DOCKETED		
Docket Number:	24-OPT-04	
Project Title:	Potentia-Viridi Battery Energy Storage System	
TN #:	265208	
Document Title:	Biological Resources Responses to CEC Emails	
Description:	Includes responses to the CEC's request and includes the following attachments: Civil Plans, Revised LSAA Application, Redlined LSAA Application, Field Forms, Resumes, Biological Opinion	
Filer:	Ronelle Candia	
Organization:	Dudek	
Submitter Role:	Applicant Consultant	
Submission Date:	8/1/2025 2:04:20 PM	
Docketed Date:	8/1/2025

CEC Data Request - Biological Resources Follow-Up Response

Potentia-Viridi Battery Energy Storage Project

POTENTIA-VIRIDI BATTERY ENERGY STORAGE SYSTEM

CDFW STREAMBED
ALTERATION
AGREEMENT

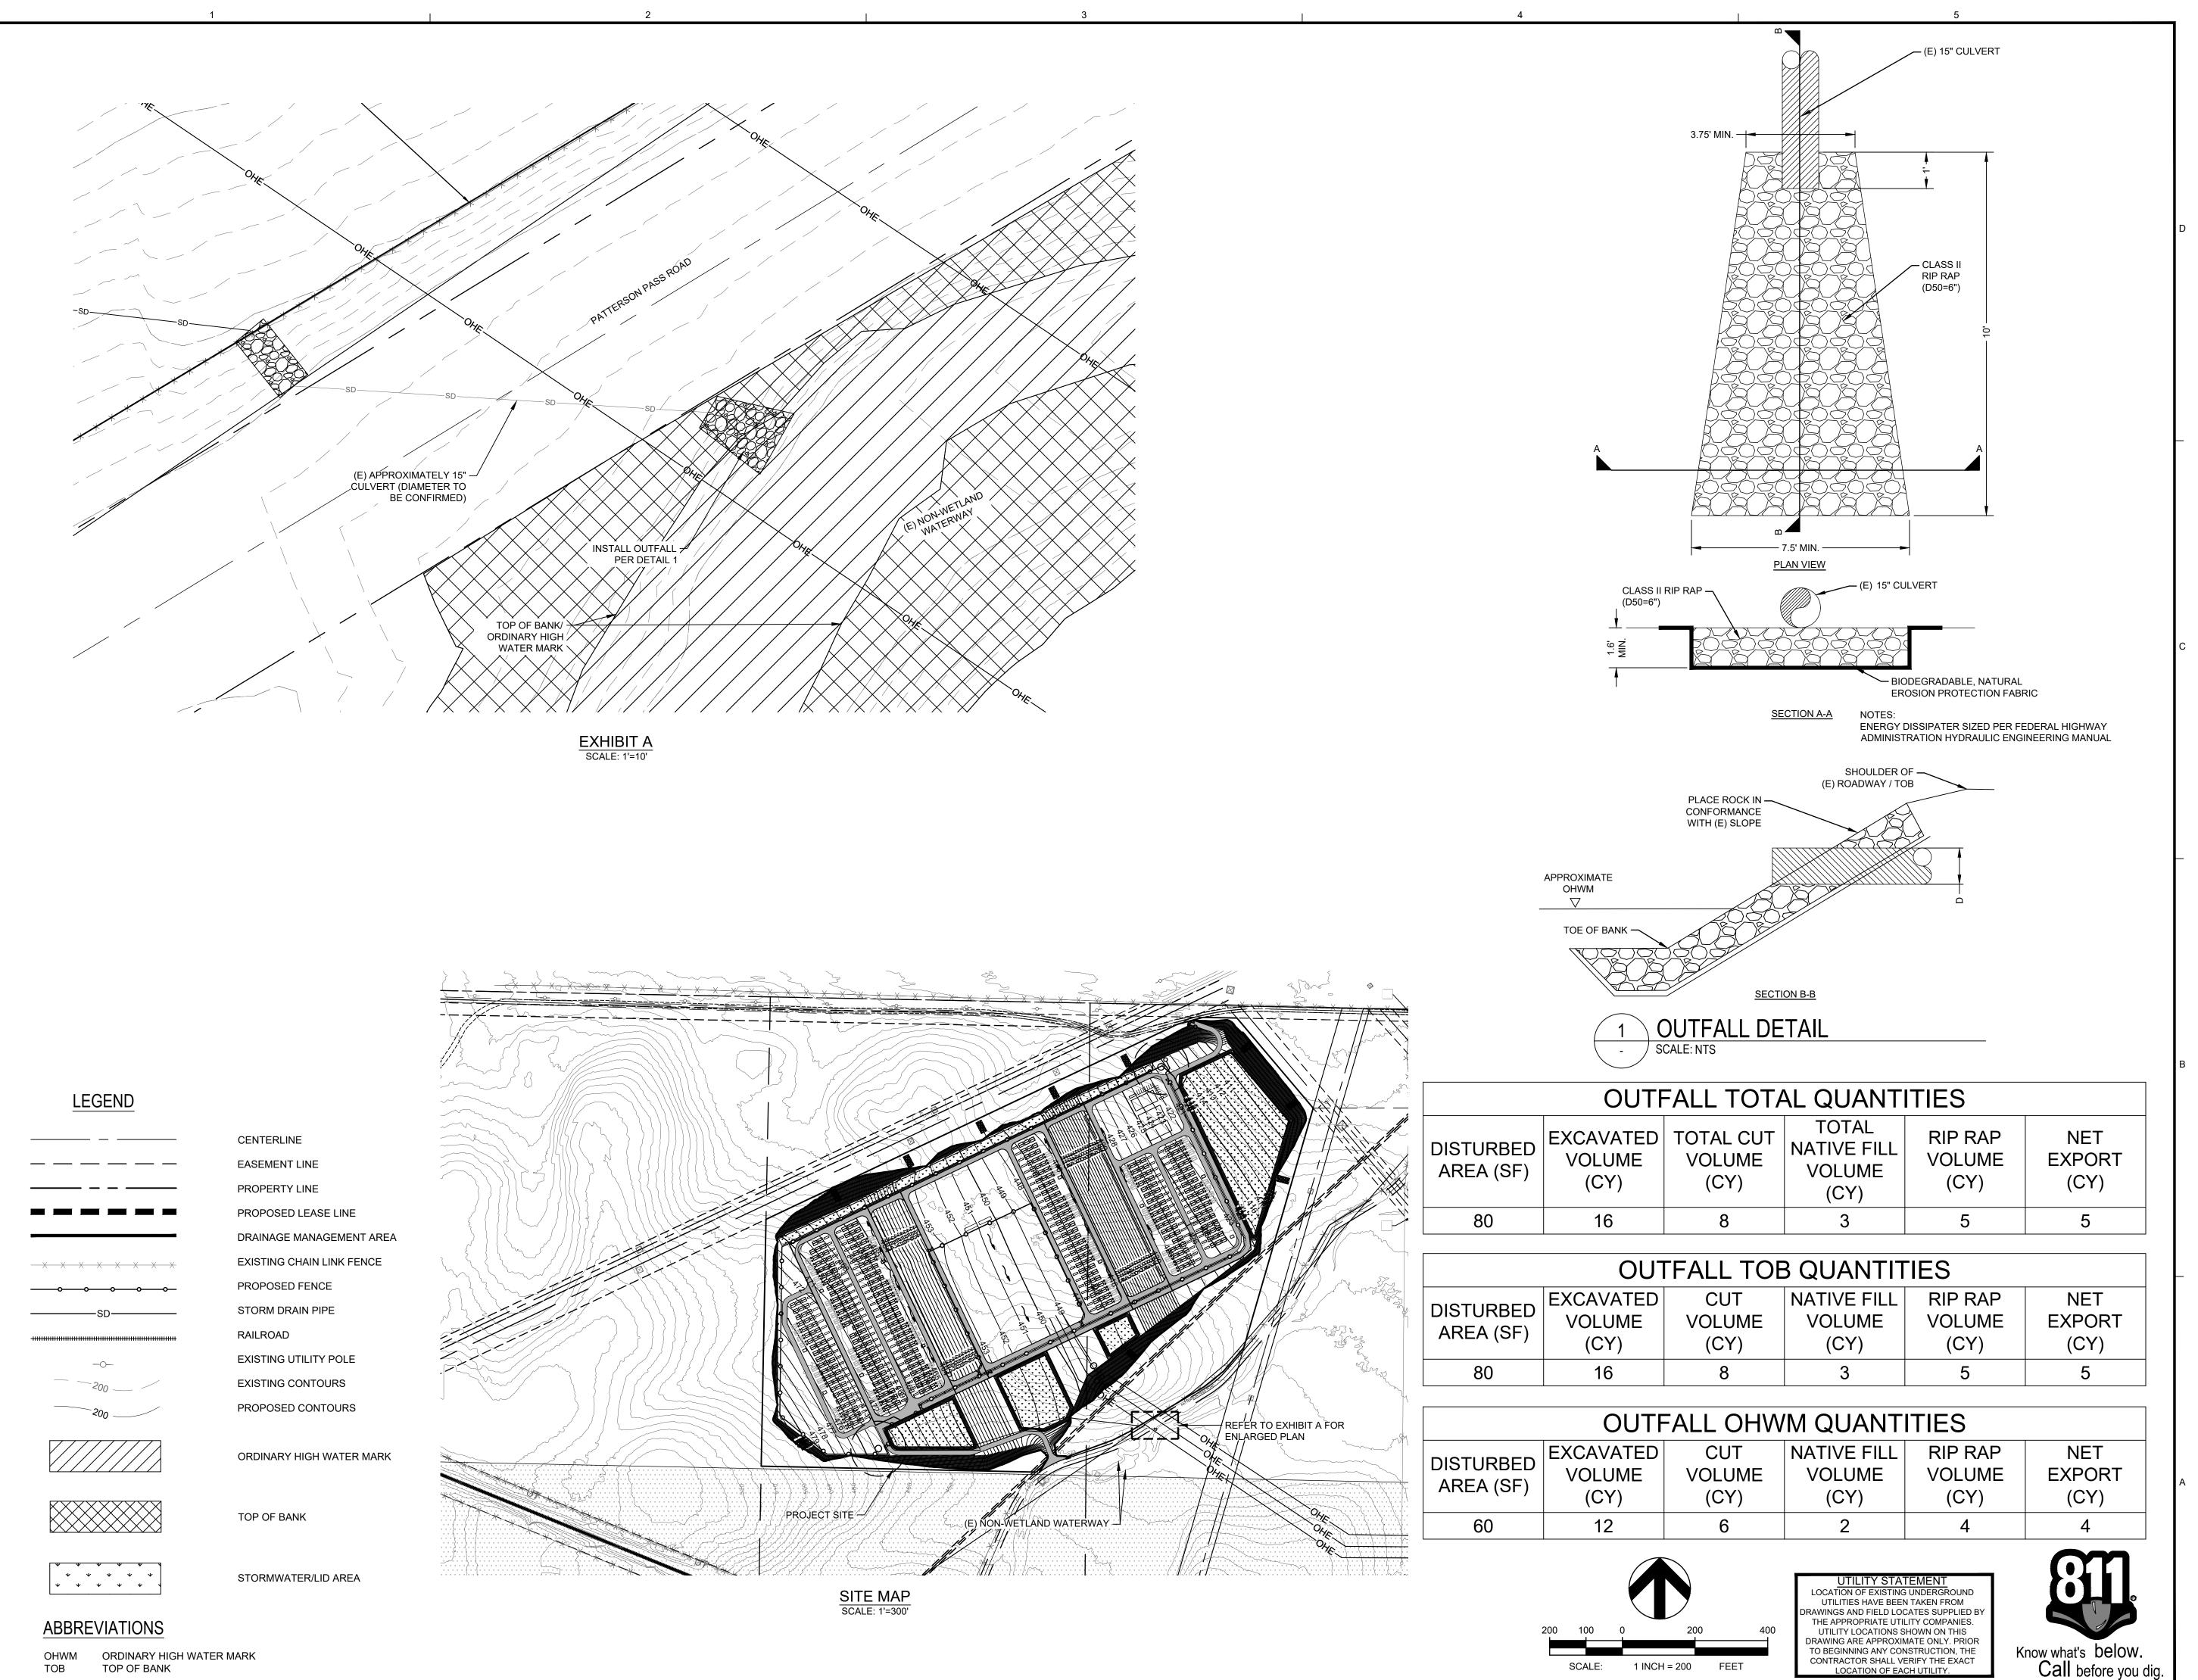
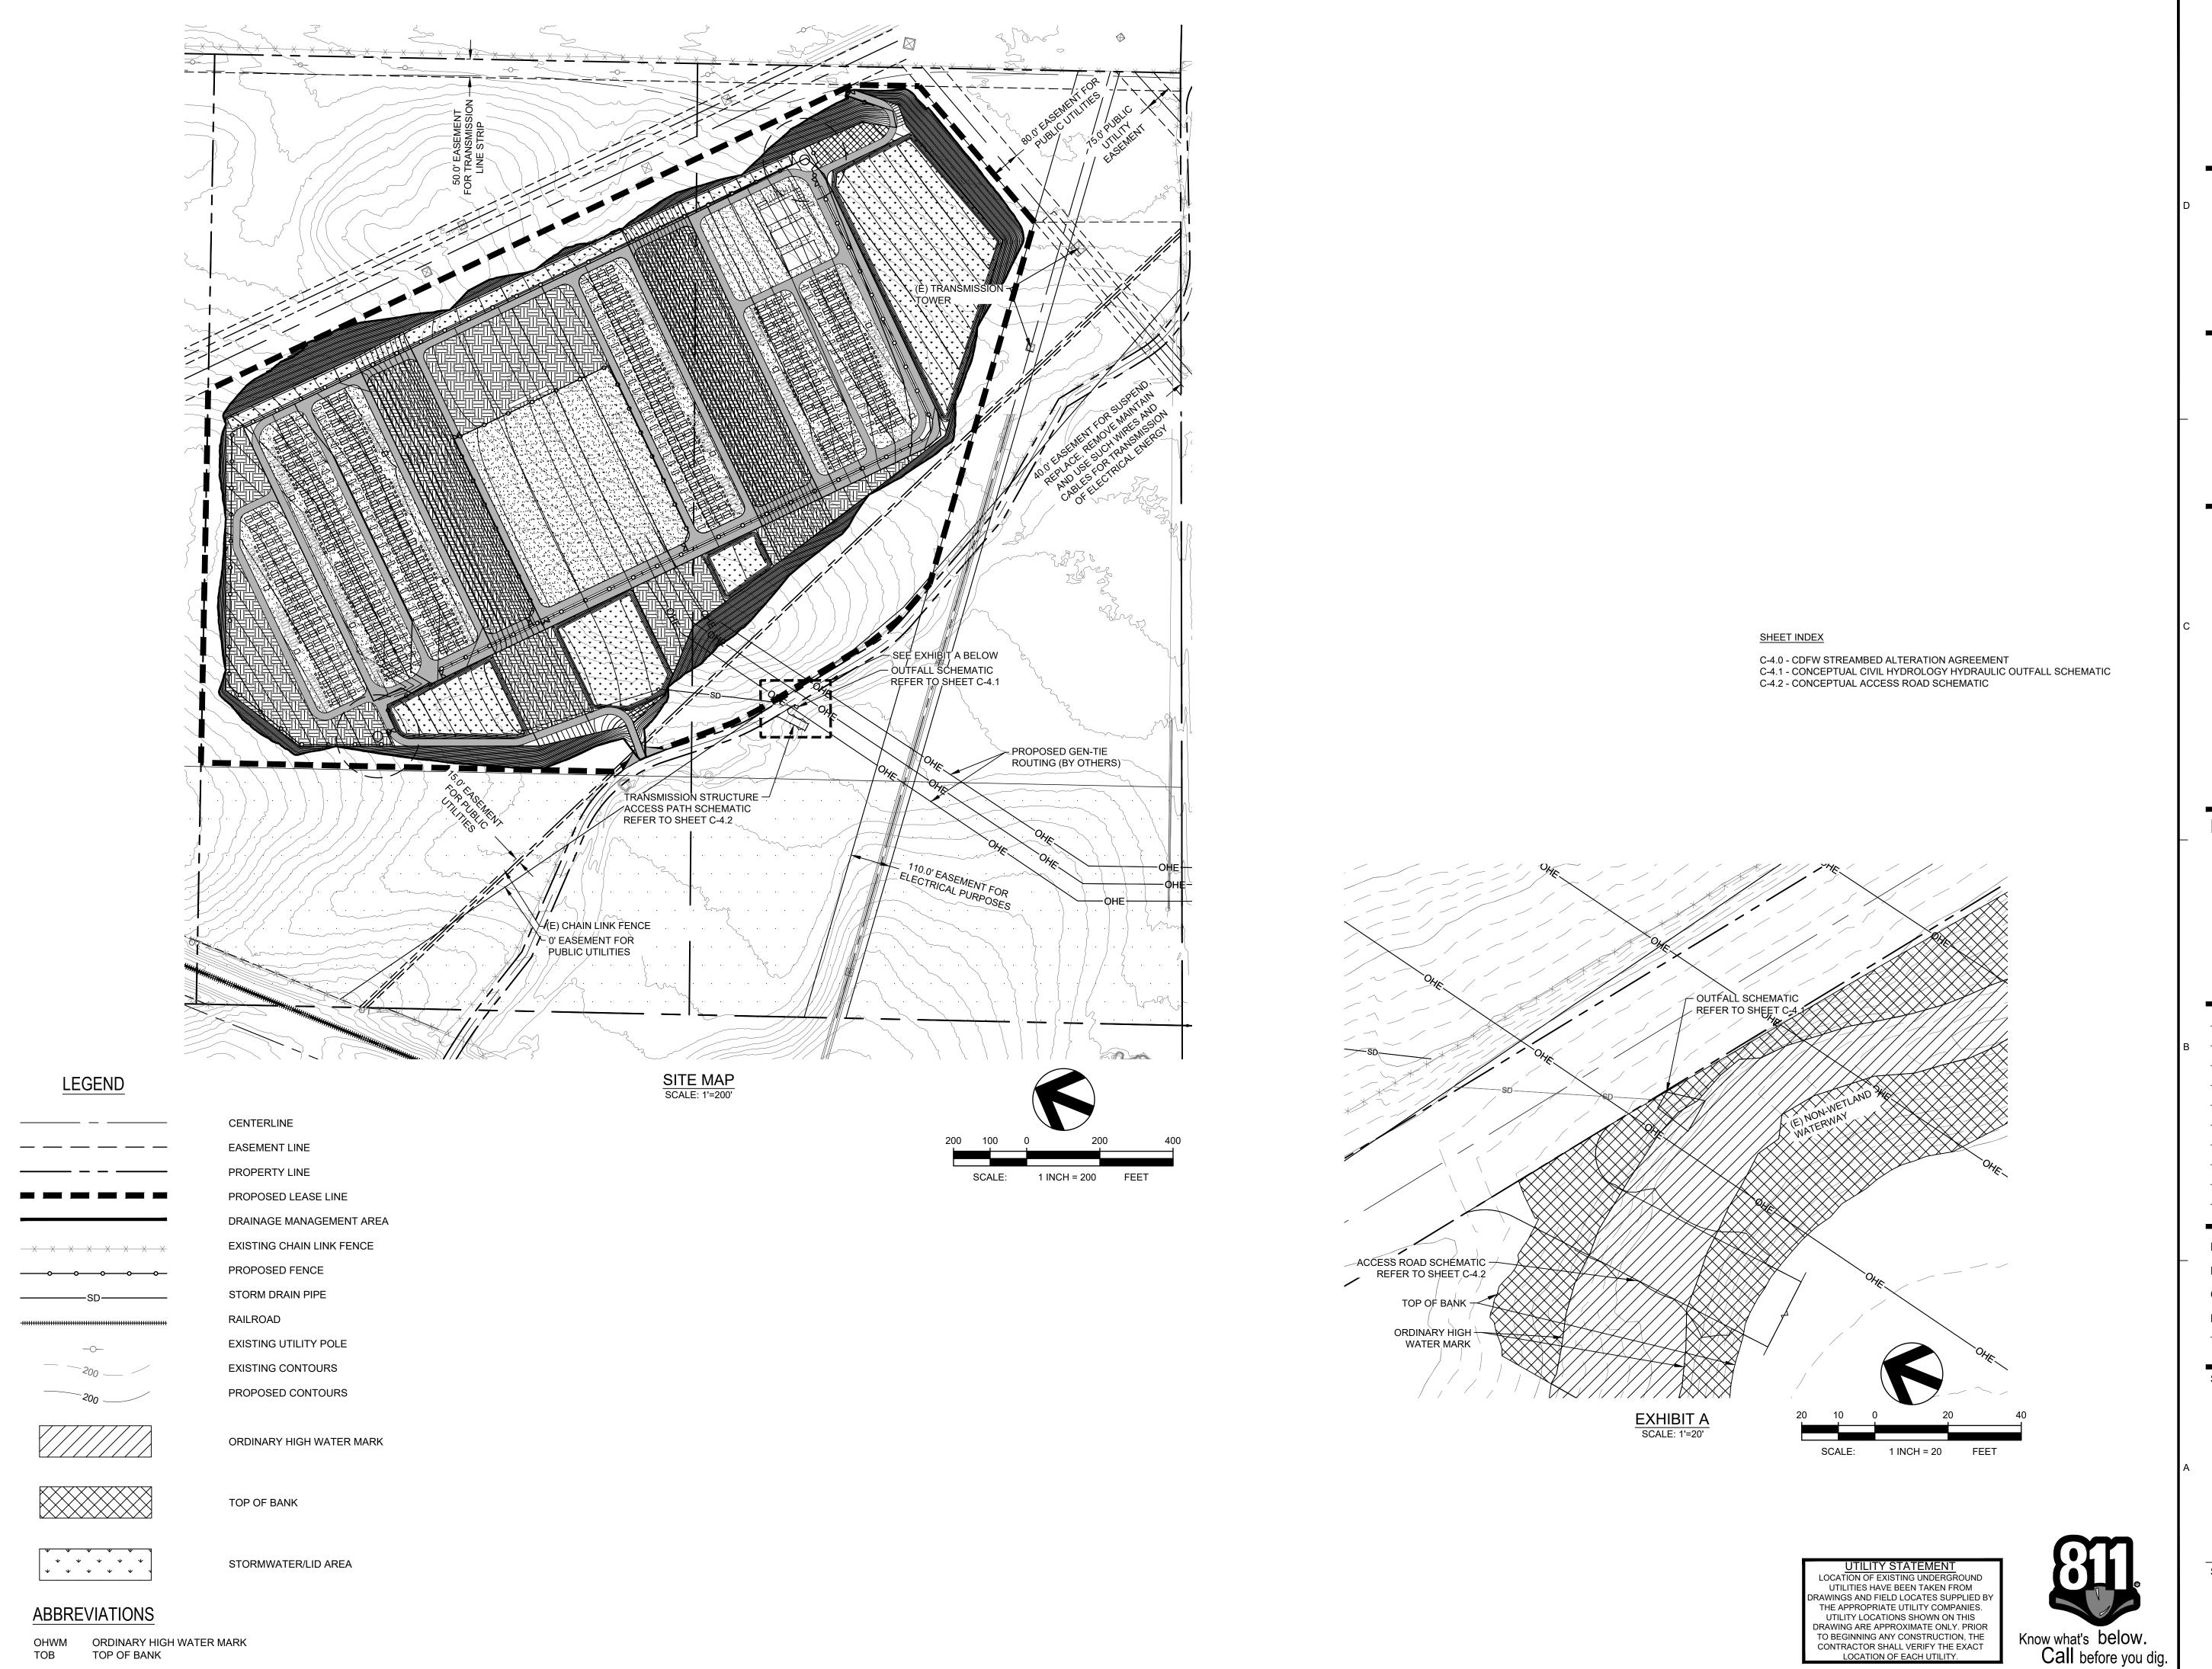
DR 1. California Department of Fish and Wildlife has completed review of the "401 Permit Figures" that you docketed (Ref. TN 264903) on 7/18/25. CDFW is requesting expansion of the area of CDFW regulatory authority to elevation 432 on the west side of Patterson Run creek and to 430 on the east. Please revise the plans to reflect CDFW jurisdictional area and provide updated impact estimates in the LSAA notification. Please revise the LSAA notification and re-submit a redline/strike-through version, to include the .kmz files.

Response: CDFW's jurisdictional area has been revised to the elevations requested and the figures have been updated accordingly and uploaded to the Docket (Attachment 1, Civil Plans). In addition, the LSAA notification has been revised and both the revised application (Attachment 2, Revised LSAA Application) and a redline/strikeout version (Attachment 3, Redlined LSAA Application) have been uploaded to the Docket. The .kmz files have been emailed directly to Mr. Eric Veerkamp for distribution.
